Three Mile Island, Unit 1
Operating License No. DPR-50
NRC Docket No. 50-289

Subject: Additional Information Concerning a Proposed Alternative Associated with the Use of a Weld Overlay

ATTACHMENT 1
RESPONSE TO ADDITIONAL QUESTIONS

ATTACHMENT 2
ESTIMATED COVERAGE MAP

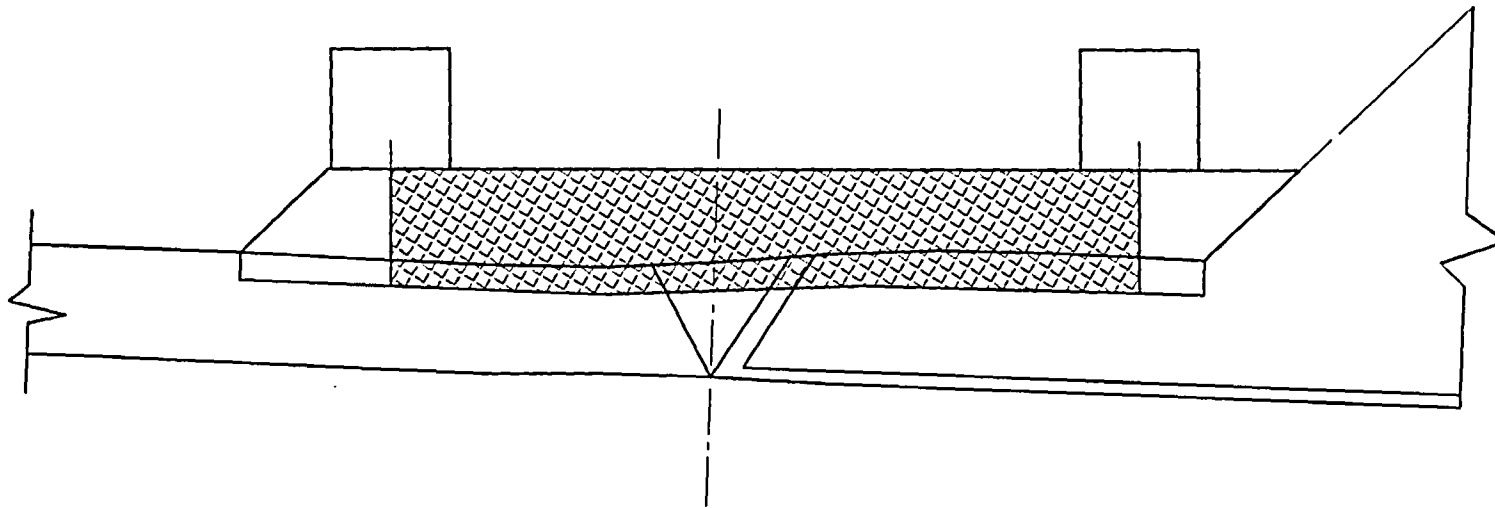
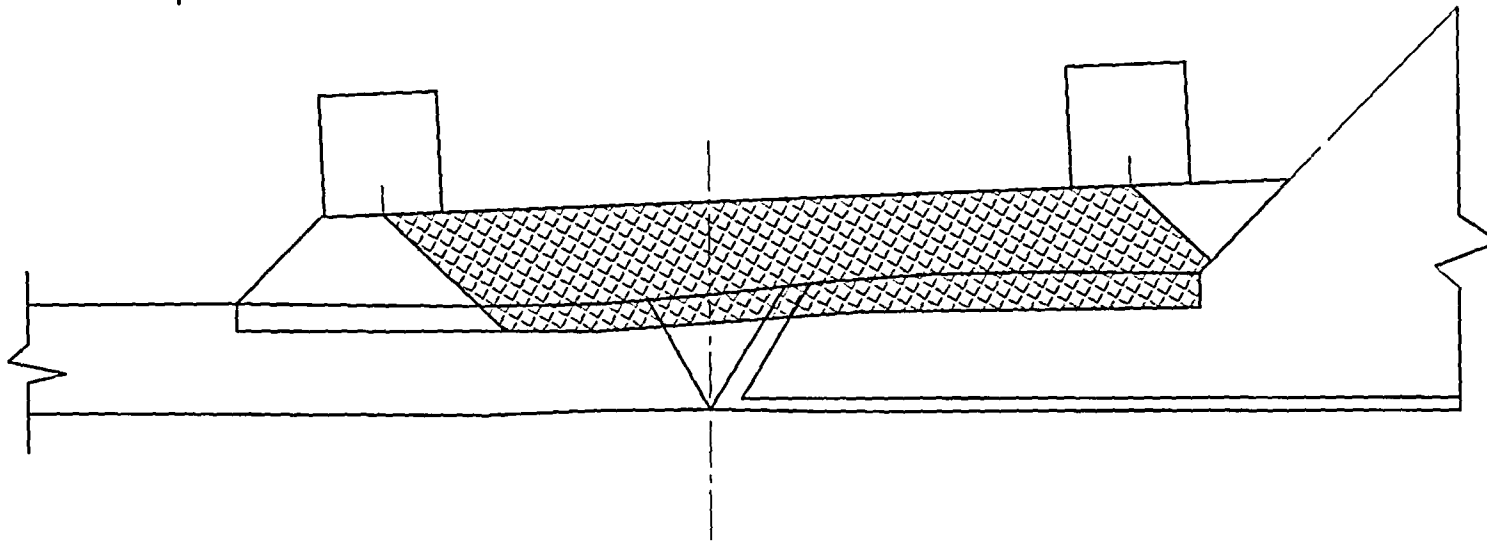
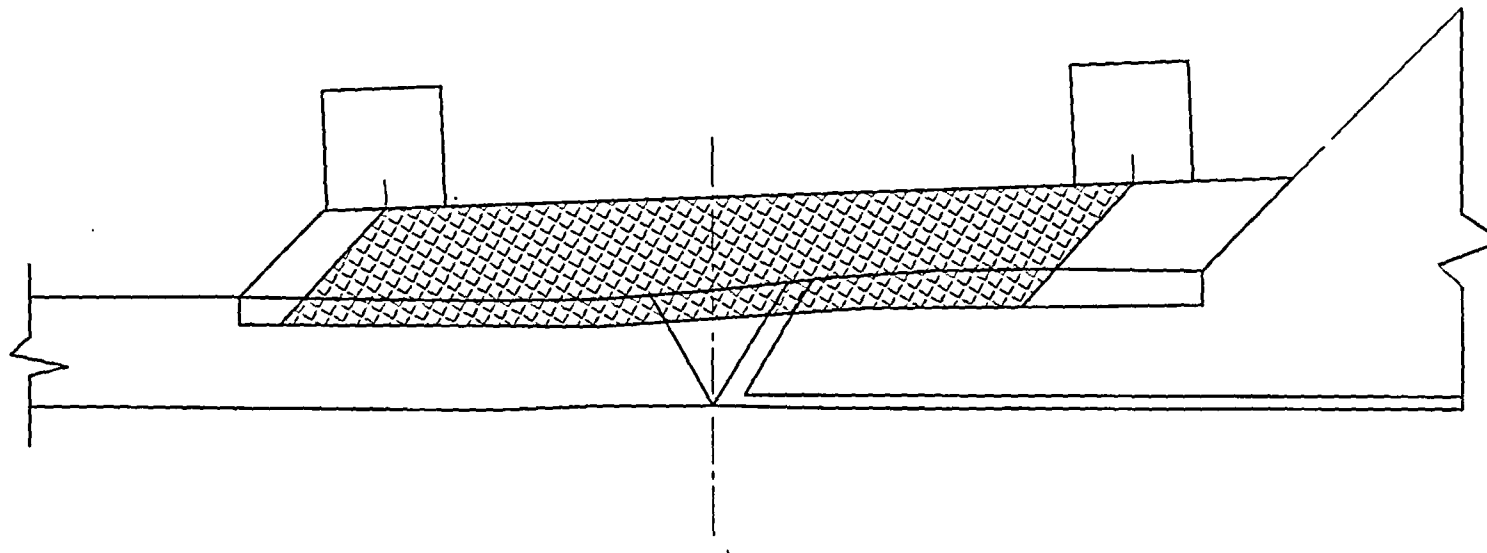
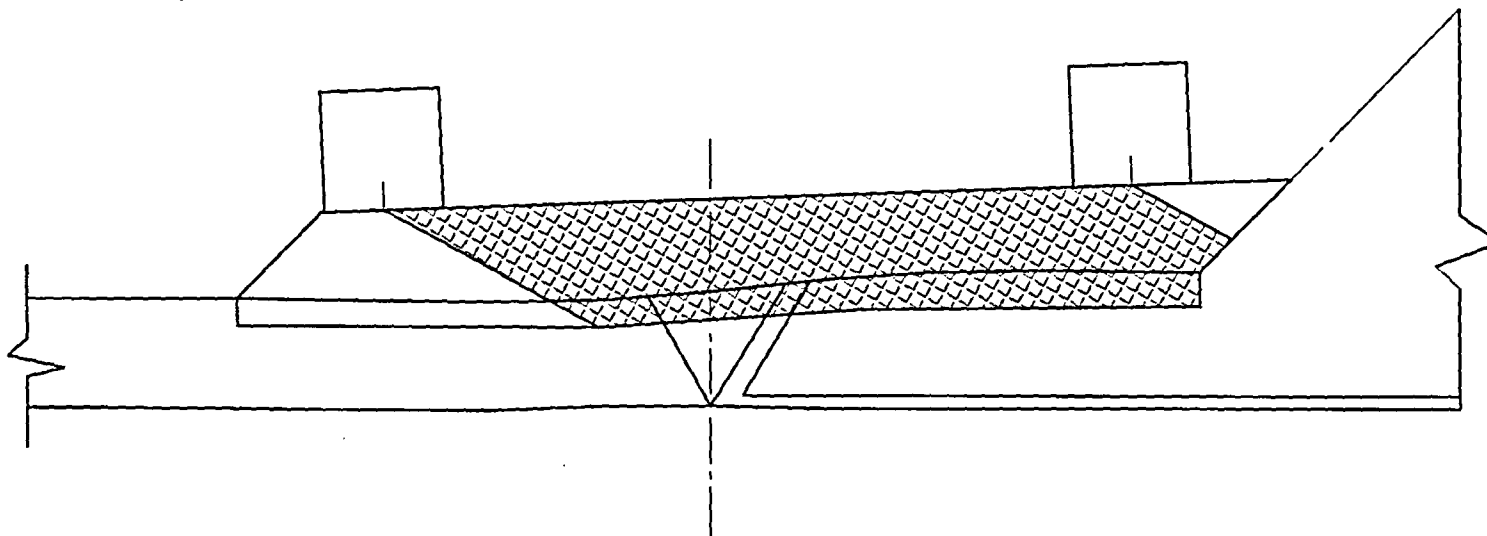
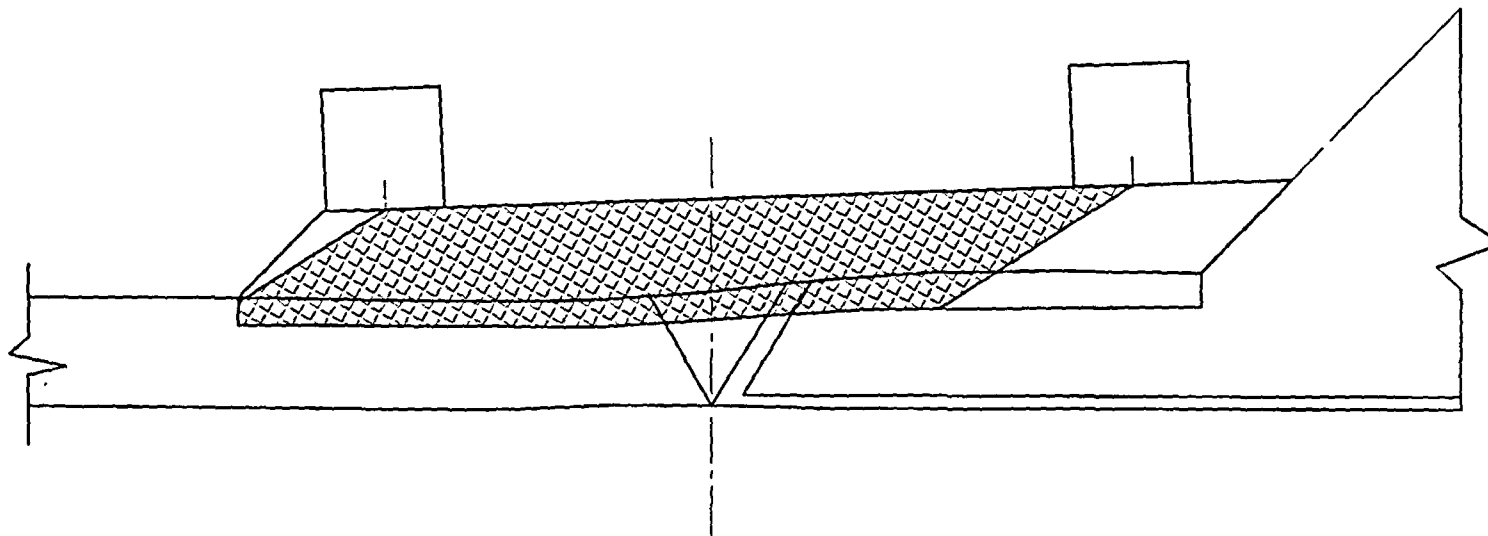
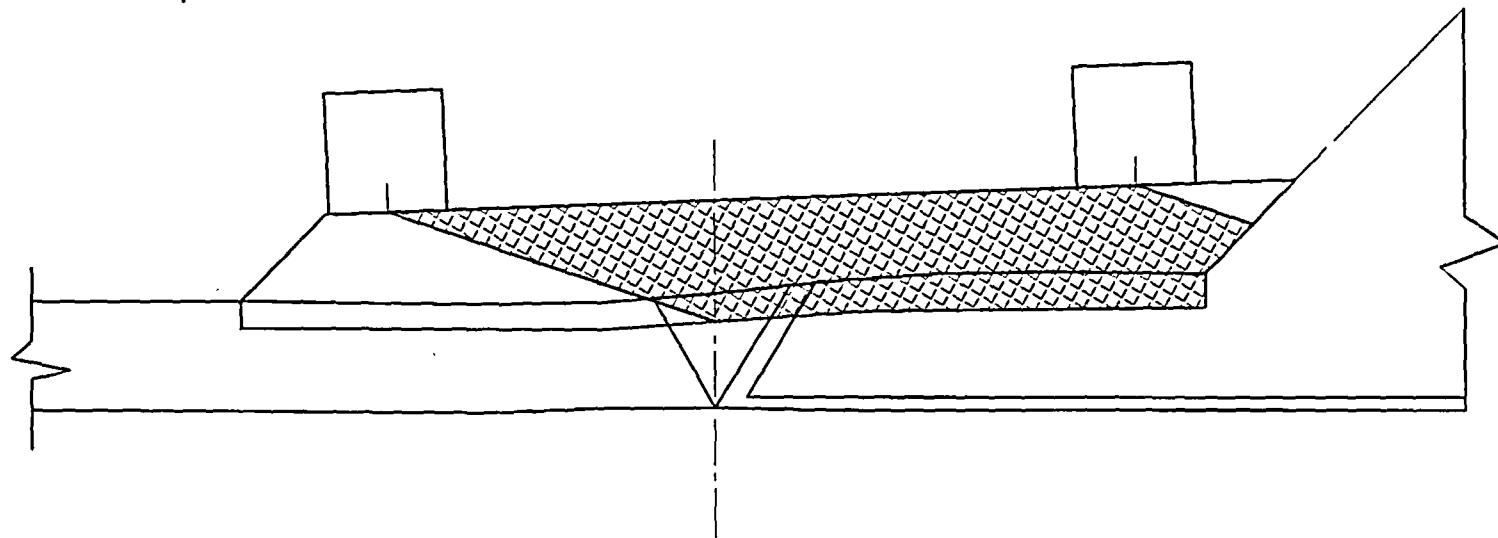
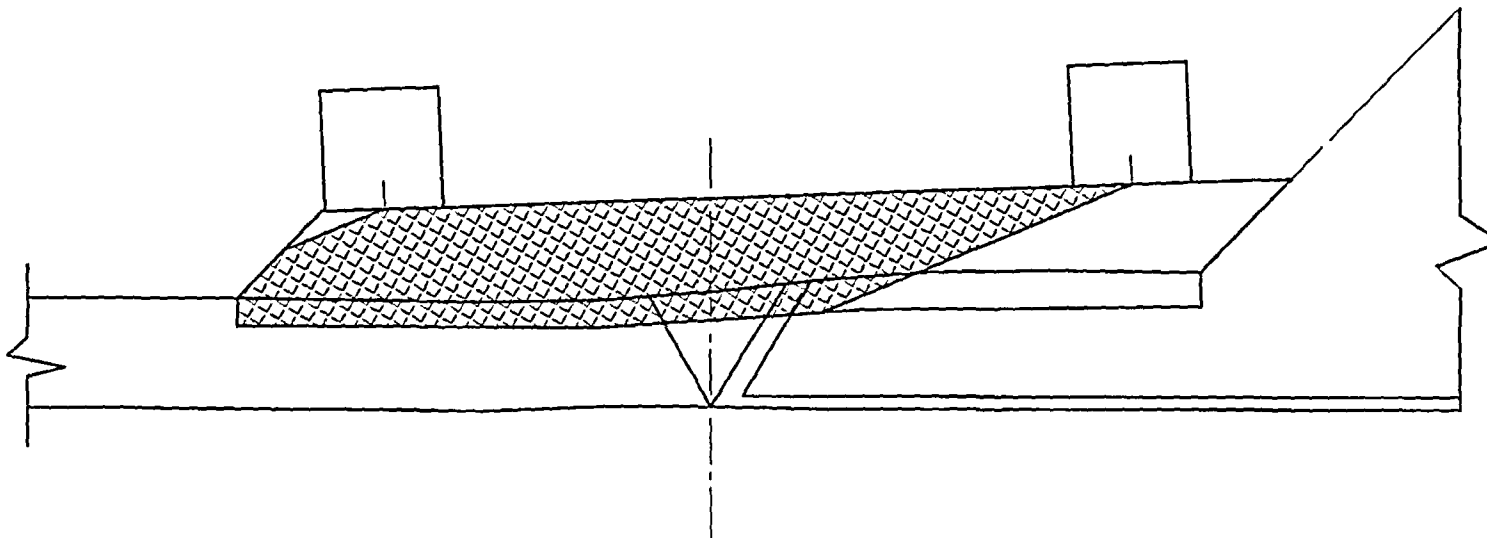
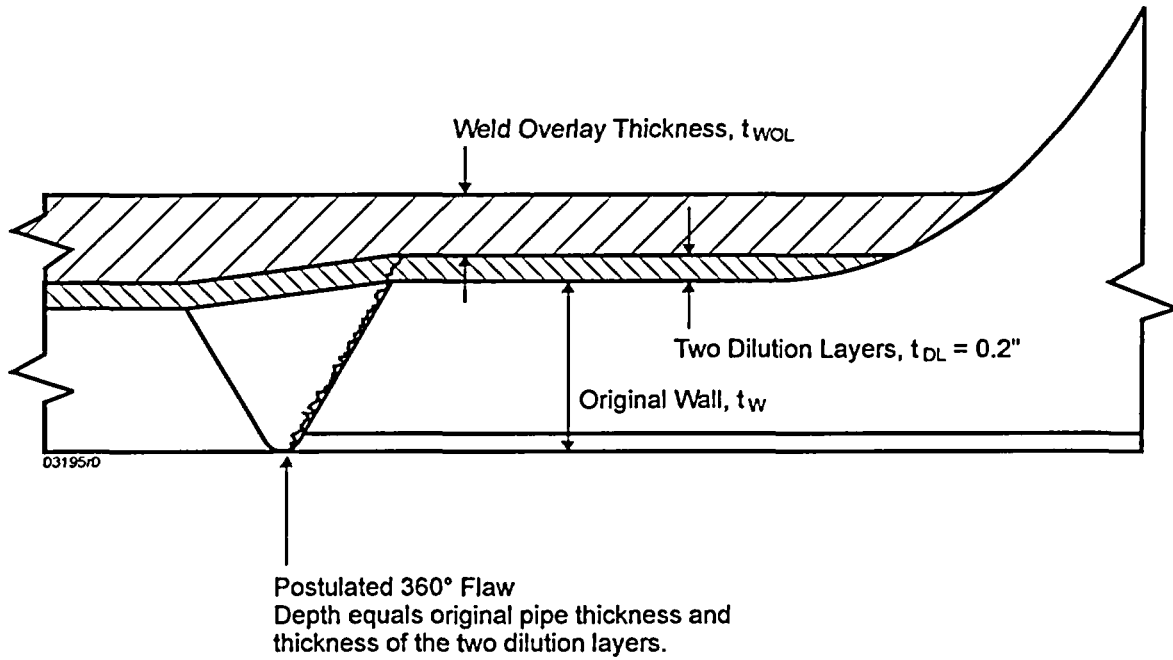
2.0 In the November 3 submittal, Table 3 states that the examination volume will be the volume examined in the PDI demonstration. Provide a sketch showing cross-section with dimensions of the PDI inspection volume. Will the inspections include the ferritic base metal beneath the overlay? If not, explain why this area is not susceptible to crack growth?

For the preservice inspection as noted in Table 2 of the Reference 1 submittal, the entire length for the full circumference of the overlay will be examined. The outer 25% of the original pipe wall will also be examined to the maximum degree allowable by the weld overlay configuration. An estimated coverage map is provided in Attachment 1.

Future inspections will be covered as discussed in Table 3 including ½ inch on either side of the original weld. Inspection on either side of the original weld will find any postulated flaw extending into the stainless steel or carbon steel. The carbon steel is not expected to have any active degradation; therefore, interrogation of the ½ inch on either side of the original weld is conservative. This is based on past IGSCC experience in BWRs.
